PALISADES PLANT SGRR
(Instructions for Entering Revision 4)

PALISADES PLANT SGRR

PALISADES PLANT
STEAM GENERATOR REPAIR REPORT

HOT SPOT
HEAT TRANSFER COEFFICIENT
FOR 2060 PSIA
Figure E-4.2-1

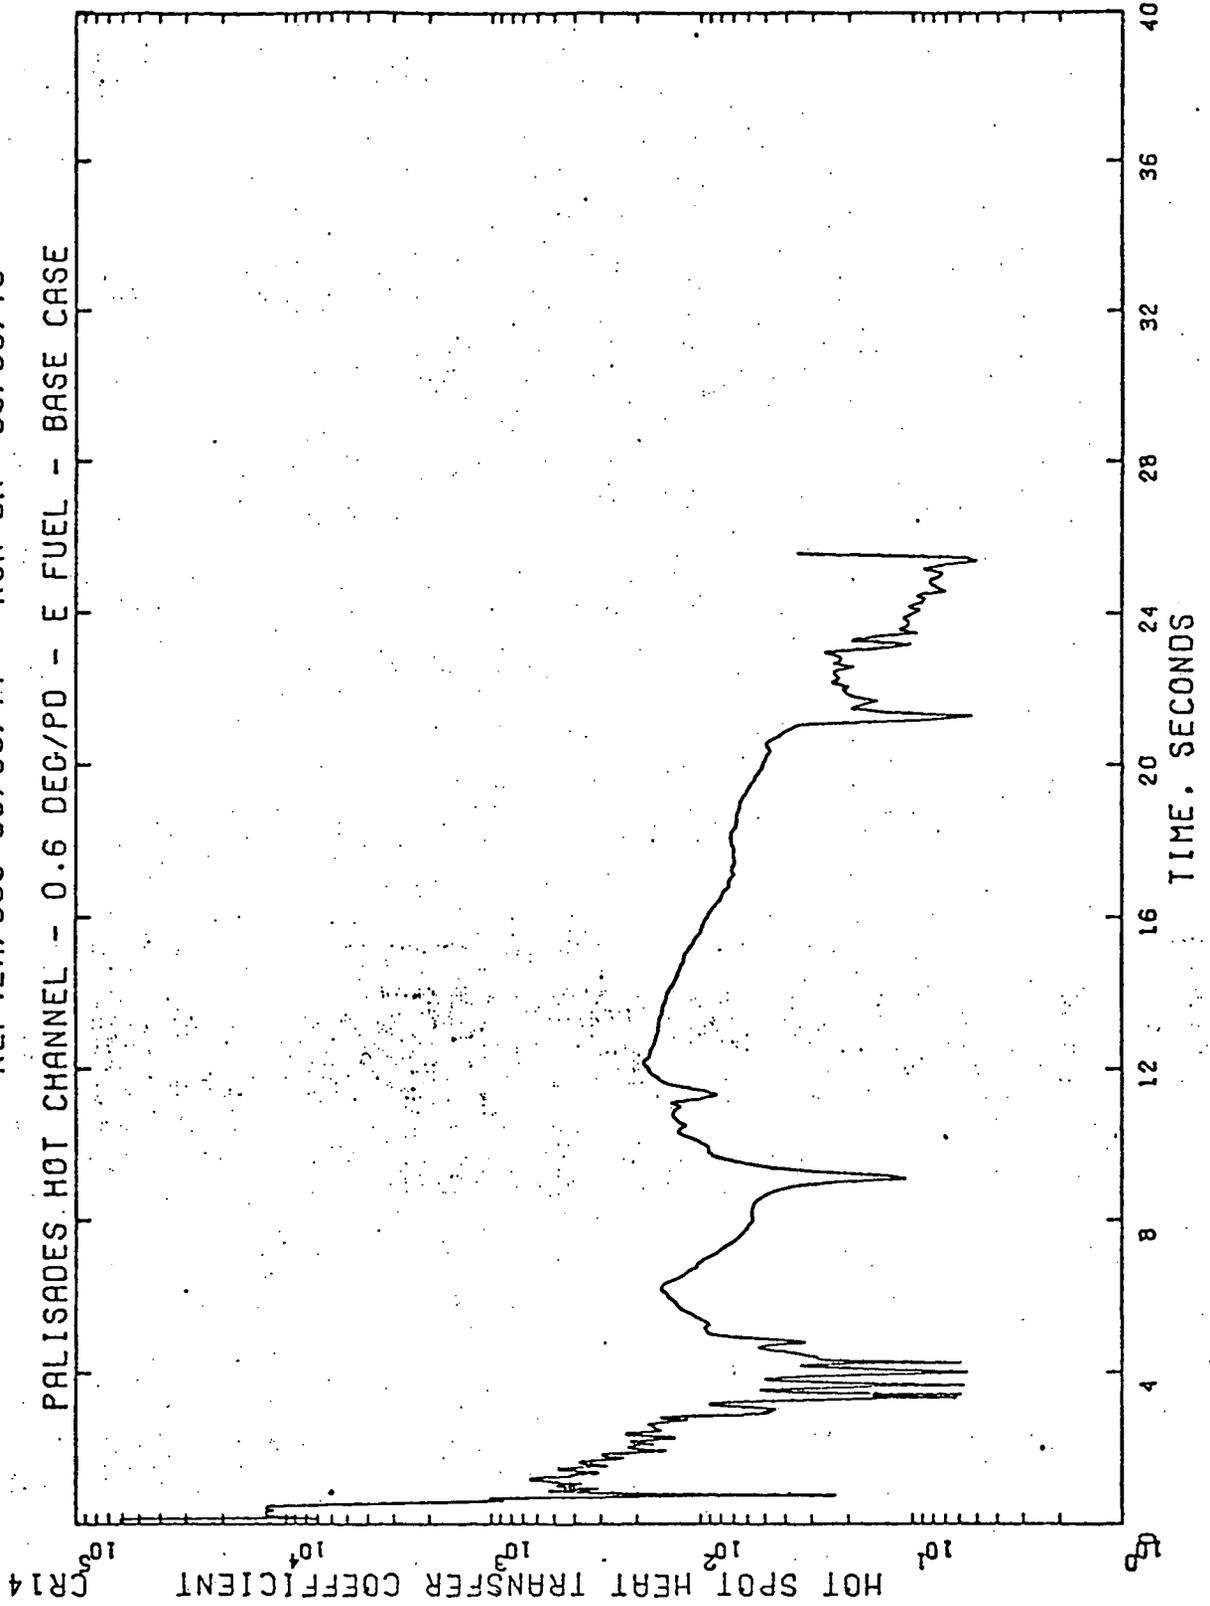
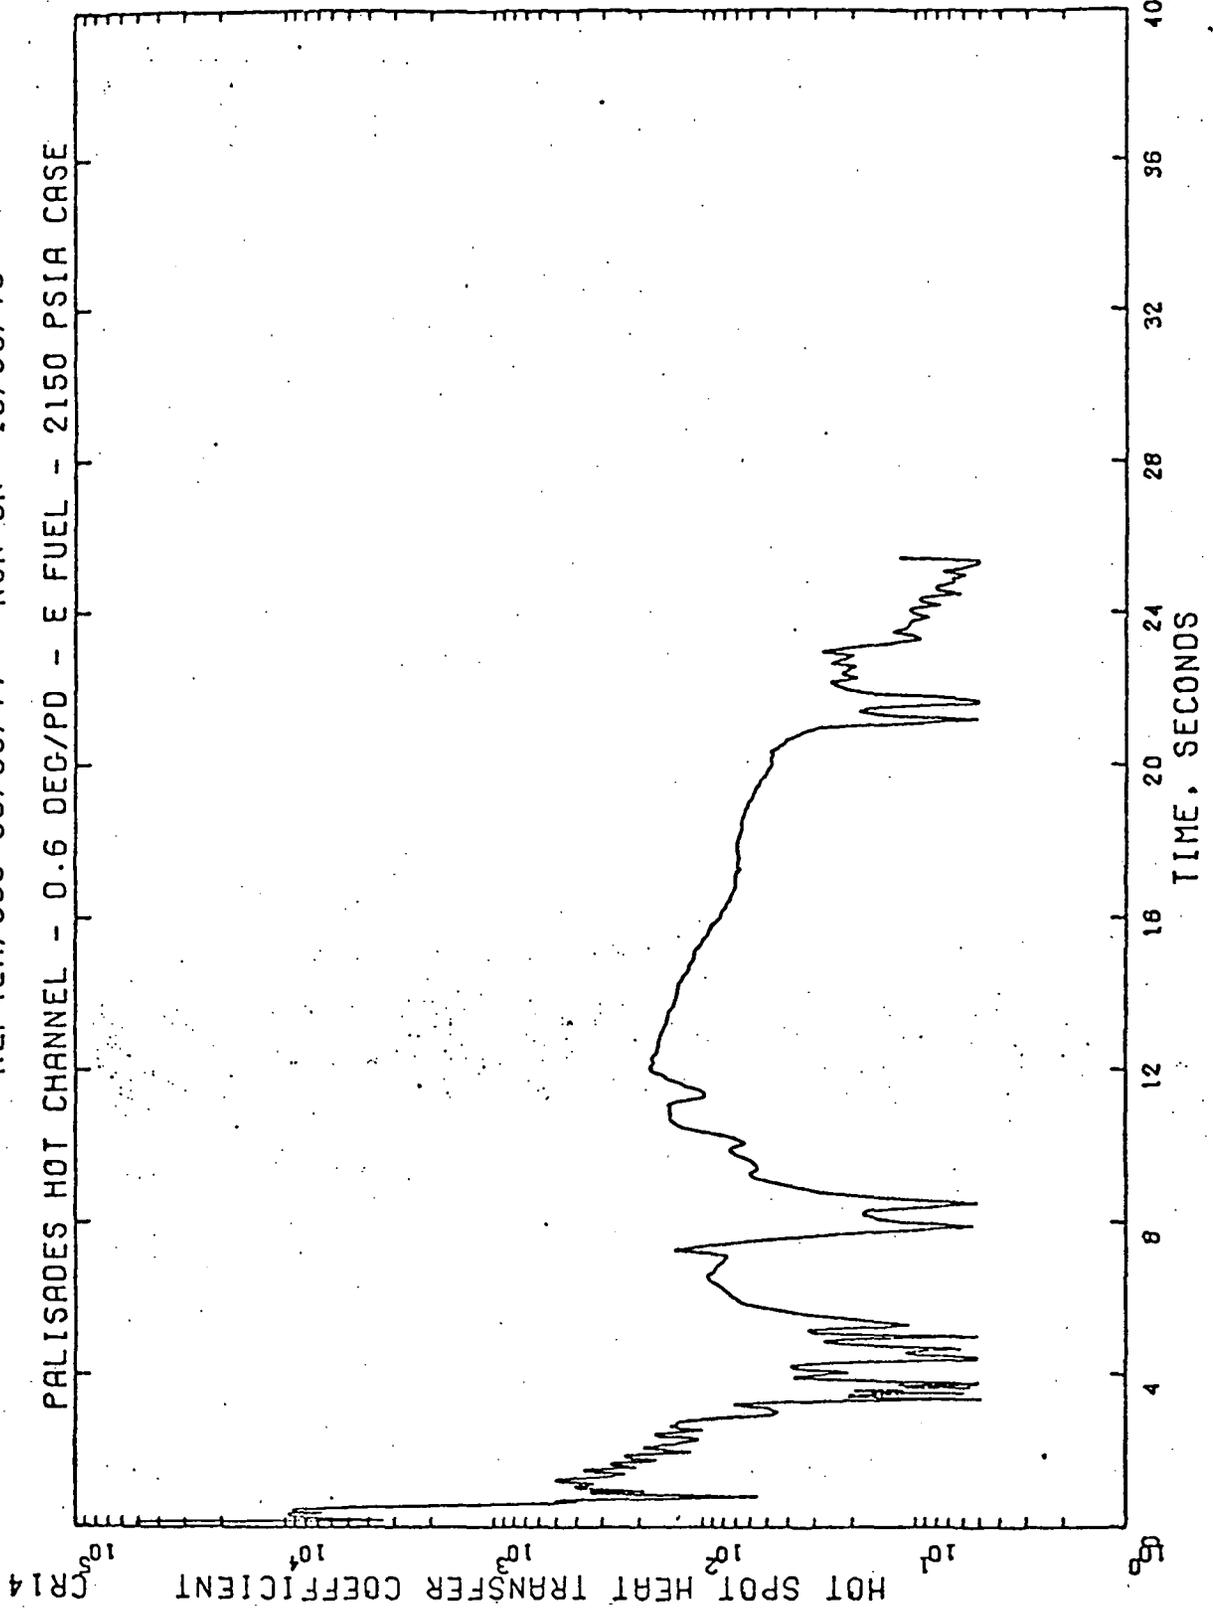
E-4.2 In Section 6.1.3 explain the effect of primary system pressure on blowdown, reflood, and peak clad temperature.

The major effect of increased primary system pressure was observed during the blowdown phase of the LOCA. With a higher pressure (2,150 versus 2,060 psia), flow through the core and hot assembly during blowdown was degraded sufficiently to result in poorer fuel rod heat transfer during blowdown and ultimately a higher peak clad temperature. For comparison purposes, the calculated heat transfer coefficient at the hot spot in the core is shown in Figures E-4.2-1 and E-4.2-2 for the base case and for the 2,150 psia case, respectively.
